STAFF RECOMMENDATION
1105 Clayton Avenue
August 15, 2018

Application: New Construction-Addition

Description of Project: The application is for a rear addition, inclusive of a ridge raise.

1 FRONT ELEVATION
A.3 SCALE: 1/4" = 1'-0"

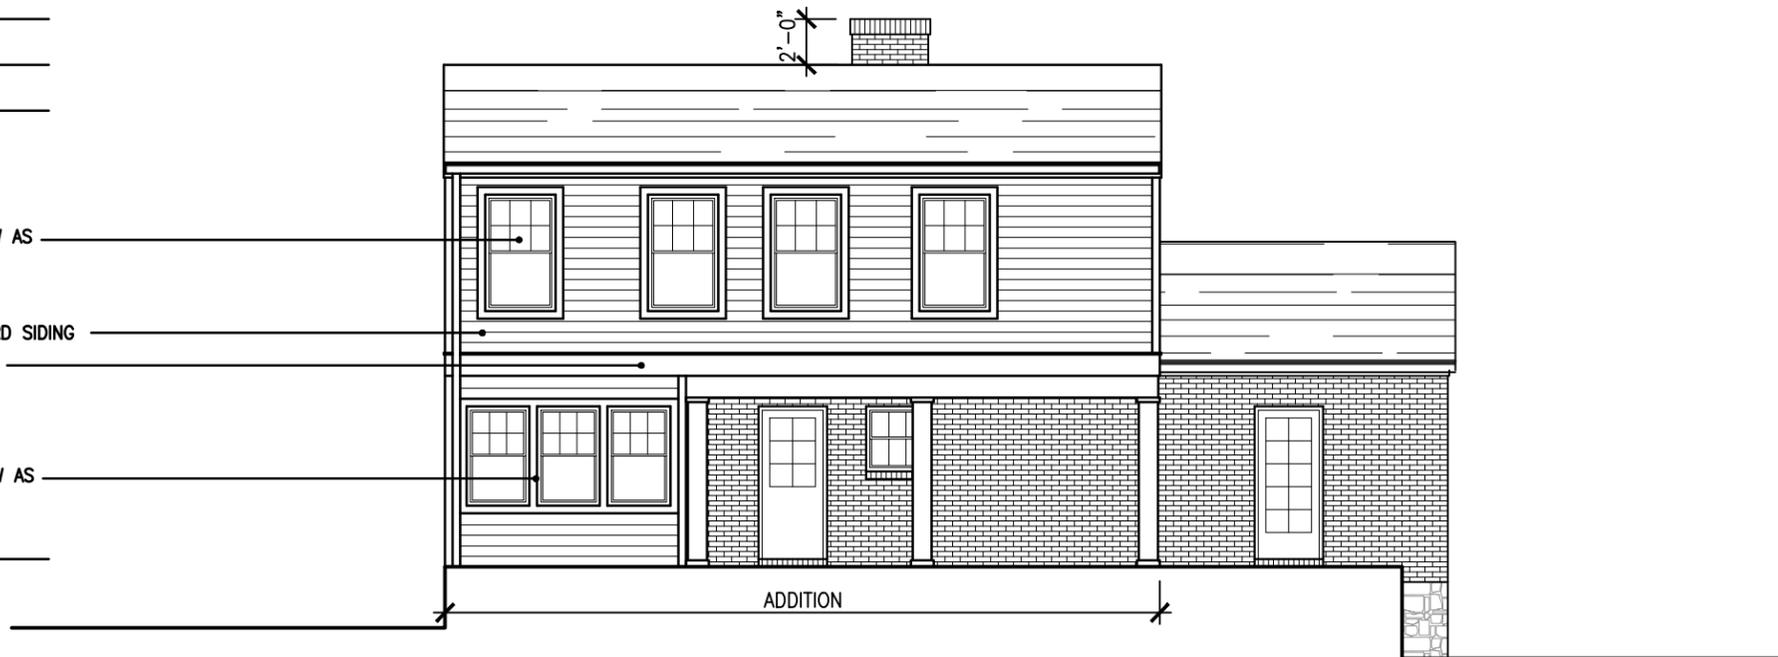
Height & Scale: The proposed addition incorporates a ridge raise, which is allowed by the design guidelines. The existing ridge is approximately nineteen feet, seven inches (19'7") from finished floor height, with the proposed new ridge being two feet (2') higher, at twenty one feet, seven inches (21'7") tall. Two foot ridge raises are permitted; however, the guidelines specifically state that ridge raises are to be inset two feet (2') on either side, and this design does not propose an inset. To date, the Commission has not deviated from that two foot (2') requirement. The purpose of the inset is to visually differentiate the new construction from the historic house; without the required insets, the original roof form of the house is lost.

Design: The addition is designed to be the same width as the historic house. The design guidelines call for additions to incorporate insets of one foot (1') per floor, such that a one story addition should be inset one foot (1') and a two story addition should be inset two feet (2'). The lack of insets in this proposed design will create a new form where the dimensions of the original house will not be discernible. Further, ridge raises are also required to utilize two foot (2') insets, which are not incorporated in this design either (Figure 4). The lack of insets at the roof changes the height of the original roof ridge and the overall proportions of the primary elevation of the house. Staff finds the design to be inappropriate without the required insets.

The project also incorporates changes to the front porch. This area was enclosed with windows and glass block prior to the establishment of the conservation overlay on this block (Figure 3). As a part of the proposed project, the applicant would like to remove the glass block on the lower portion of the exterior wall and replace it with siding (Figure 4). The three windows above would also be replaced with new windows. As the porch is already enclosed, staff has no objection to the existing glass being replaced, but replacing the glass block with siding will decrease the transparency of this formerly open porch. Staff recommends windows that are approximately six feet (6') tall with a trim board below so that there is no wall cladding, allowing for the open design of the porch to be retained.

Roof form: The historic house has a side gabled roof with an 8/12 slope. The proposed addition utilizes a ridge raise. The design guidelines allow for ridge raises, but require a two foot (2') inset on either side, which the proposal does not incorporate (Figure 3). Failure to provide the insets results in a new roofline wherein the original historic roof height cannot be discerned. Staff finds that without the side insets, the ridge raise is not compatible with the historic roof and is not appropriate. Staff recommends that the ridge raise incorporate the required two foot (2') side insets. With this condition, staff finds that the project meets section II.B.1.e for new construction-roof form and II.B.2.a for additions.

Staff recommends that the addition be inset by two feet (2') on either side, inclusive of the ridge raise, and that the front wall of the enclosed porch remain primarily glazing. With these conditions, staff finds that the project meets sections II.B.2.a, c for design for additions.

1. The first floor addition will be inset by a minimum of one foot (1') and the second floor, inclusive of the ridge raise, will be inset a minimum of two feet (2'); and
2. The front wall of the enclosed porch shall use windows approximately six feet (6') tall with a trim board below; and
3. Staff approve the final foundation material, roofing color and windows, prior to purchase and installation; and,
4. The HVAC shall be located behind the house or on either side, beyond the mid-point of the house.

2 REAR ELEVATION
A.3 SCALE: 1/4" = 1'-0"

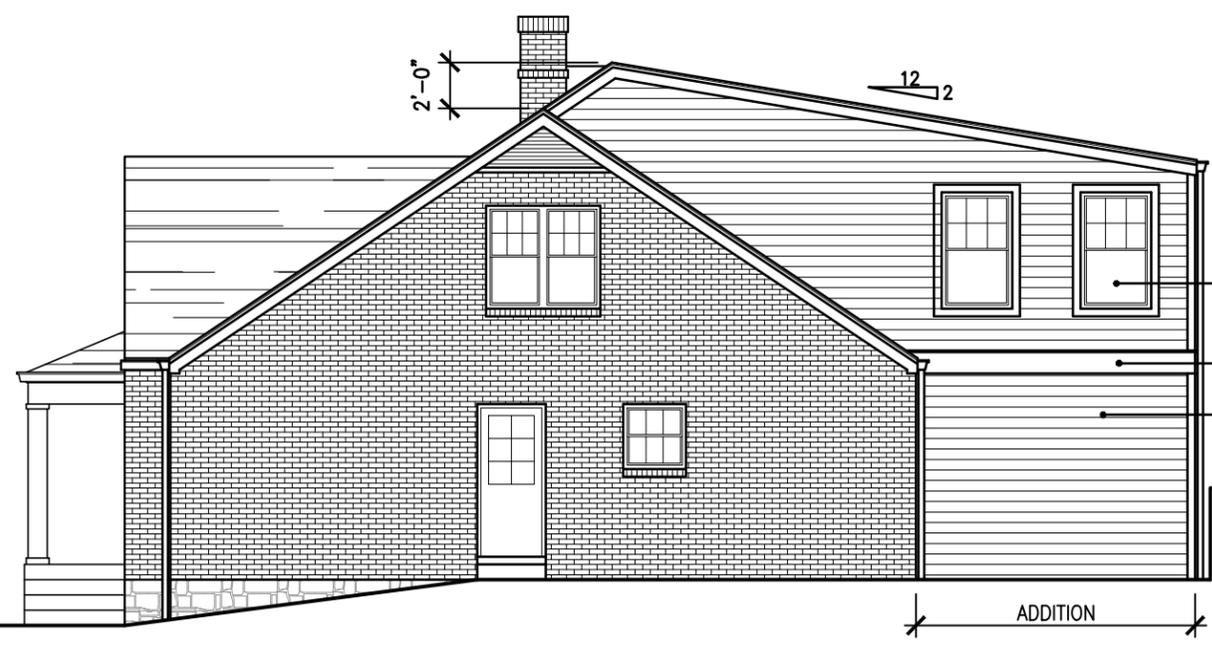
Demolition: Partial demolition will occur on the rear elevation of the structure, including removing a non-historic screened porch and the back slope of the side gabled roof, to allow for the addition (Figure 2). Staff finds that this partial demolition is appropriate because this portion of the house is not visible from the public right of way and does not contribute to the historic or architectural character of the overlay. The proposed partial demolition meets Section V.2 for appropriate demolition and does not meet section V.1 for inappropriate demolition.

As proposed, the exterior walls of the addition, on both the first and second floors, will be flush with the historic side walls of the house. The guidelines require that additions be inset, one foot (1') per floor, to differentiate the new construction from the historic house.
